Access Compliance Report

Public Rights-of-Way

Intersection ID: 14762	Main Street: E_TREMONT_AV	Cross Street: SPRINGDALE_AV	Location:	E
ADA ID: DEF1C86D118C	Ramp Type: Directional1	Initial Pass/Fail: Fail	Overall Compliance: No	Severity Score: 10

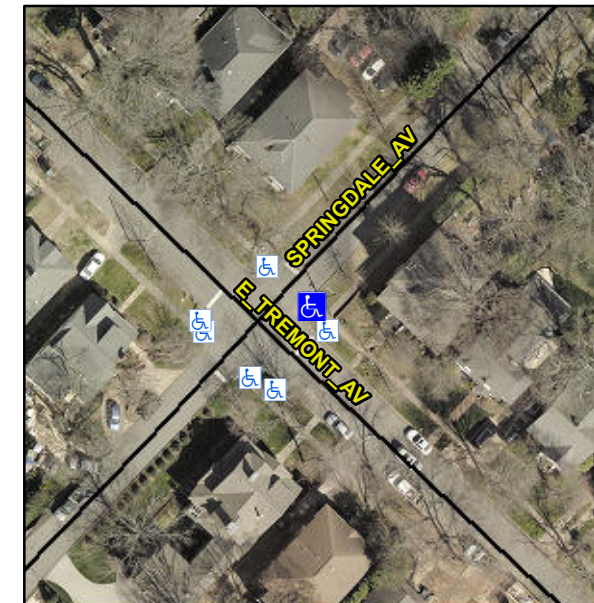
R304.5.1, R304.5.3

Remove & Replace Entire Ramp.
